**SUBJECT:** NuScale Power, LLC Supplemental Response to NRC Request for Additional Information No. 131 (eRAI No. 8970) on the NuScale Design Certification Application

NuScale Supplemental Response to NRC Request for Additional Information eRAI No. 8970

**NRC Question No.:** 03.08.04-10

**Figure 3B-48: Elevation View of the NPM NuScale Power Module Base Support Assembly at Reactor Building RXB Pool Floor**

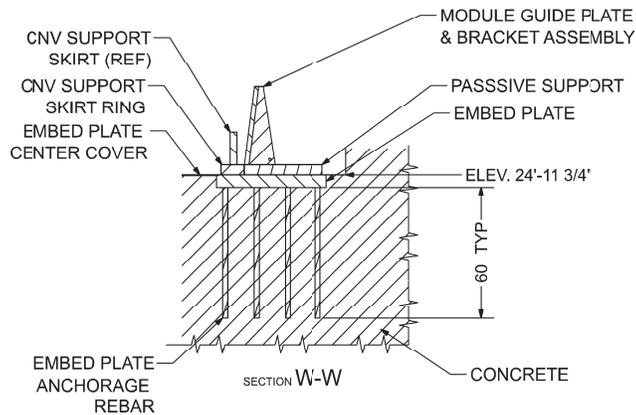
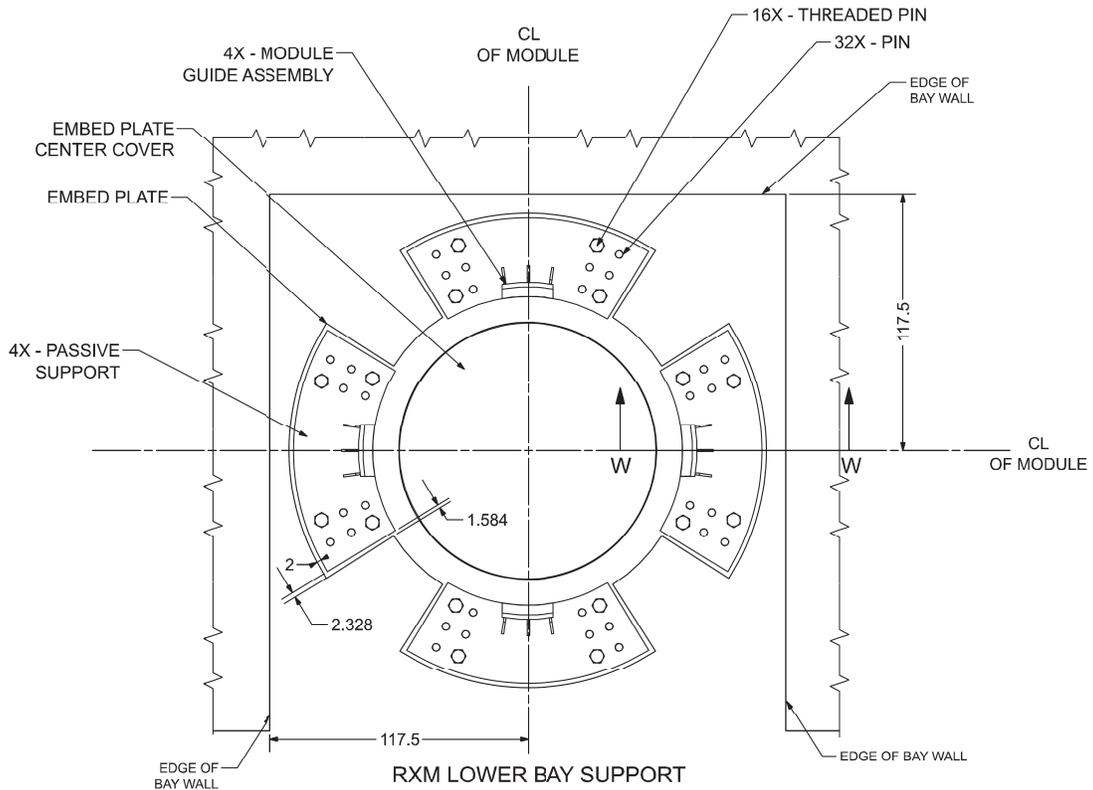
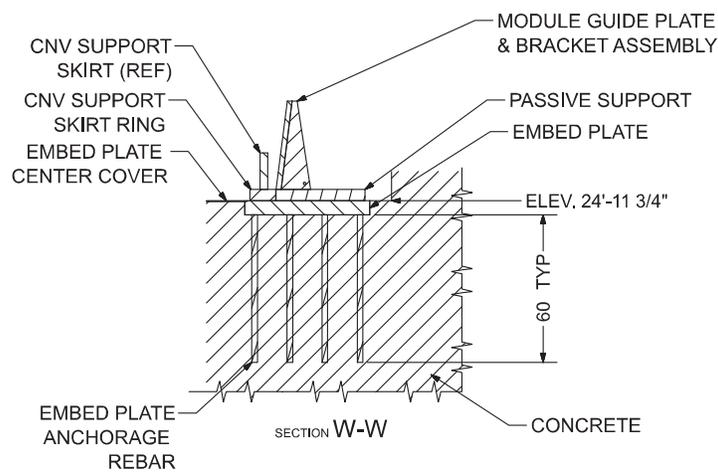
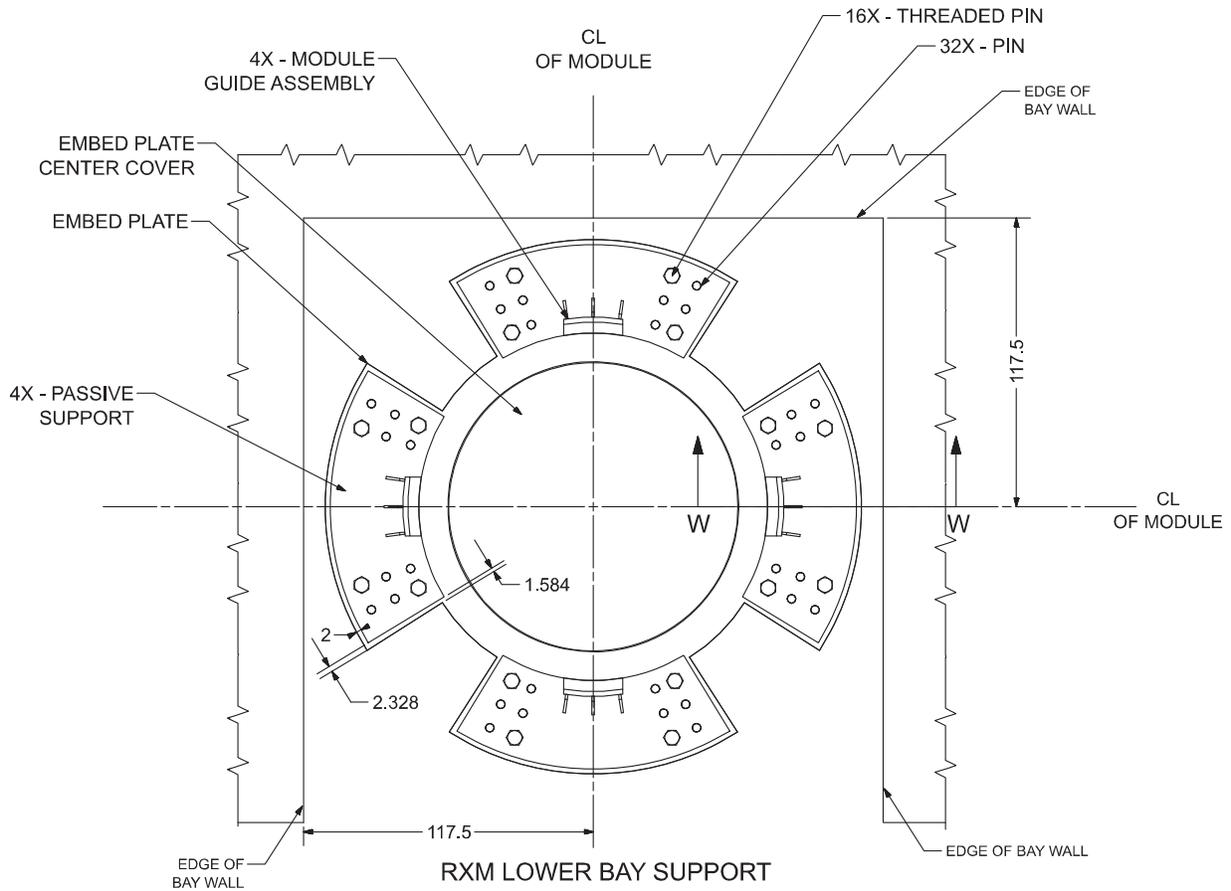
The staff notes that the response focuses on the determination of loads for the NPM supports, however it lacks details with respect to the determination of the strength of the NPM supports.

Further, based on the RAI response and FSAR information (including updated information provided in response to RAI 8975, Question 3.8.4-71) the staff was not able to confirm the D/C ratio for the bolts connecting the passive support ring to the embedded bearing plate at the bottom of the NPM support.

Therefore the staff request the applicant to clarify which provisions and or information (e.g. material properties) from N690-12 and additional codes referenced in the response were used in the determination of the strength of the NPM steel supports.

FSAR Tier 2, Appendix 3B.2.7.3 and Figures 3B-48 through 3B-50 have been revised as described in the response above and as shown in the markup provided in this response.

- The NPM is laterally restrained by four 4 1/2 in. thick stainless steel passive support plates. Each passive support plate is attached to the embed plate using two groups of six bolt/pin sets at both ends. Each set of bolts/pins is designed for the full seismic load. The passive plates transfer the seismic loads to the embed plate through the two groups of bolts/pins mainly by shear. The guide plate assembly, as shown in Figure 3B-48 is welded to the passive plate. The function of the guide plate assembly is to guide NPM installation to design position. Figure 3B-48 shows the details of passive plates and the guide plate assembly. ~~an 8 in. thick passive support ring made of stainless steel bolted to the underlying bearing plate. At the inside periphery of the passive ring, a beveled edge at the top is provided in order to guide the NPM at initial placement and during its removal and replacement for refueling operation.~~ If the NPM impacts the passive support ring plates, the resulting upward vertical and horizontal loads will be resisted by the ~~concrete~~ anchors in tension and shear and concrete in edge bearing. Figure 3B-48 and Figure 3B-49 show the details of the passive support ring.

- The NPM is laterally restrained by four 4 1/2 in. thick stainless steel passive support plates. Each passive support plate is attached to the embed plate using two groups of six bolt/pin sets at both ends. Each set of bolts/pins is designed for the full seismic load. The passive plates transfer the seismic loads to the embed plate through the two groups of bolts/pins mainly by shear. The guide plate assembly, as shown in Figure 3B-48, is welded to the passive plate. The function of the guide plate assembly is to guide NPM installation to the design position. Figure 3B-48 shows the details of passive plates and the guide plate assembly. ~~an 8-in.-thick passive support ring made of stainless steel bolted to the underlying bearing plate. At the inside periphery of the passive ring, a beveled edge at the top is provided in order to guide the NPM at initial placement and during its removal and replacement for refueling operation.~~ If the NPM impacts the passive support ring ~~plates~~, the resulting upward vertical and horizontal loads will be resisted by the ~~concrete~~ anchors in tension and shear and concrete in edge bearing. Figure 3B-48 and Figure 3B-49 show the details of the passive support plate ~~ring~~.
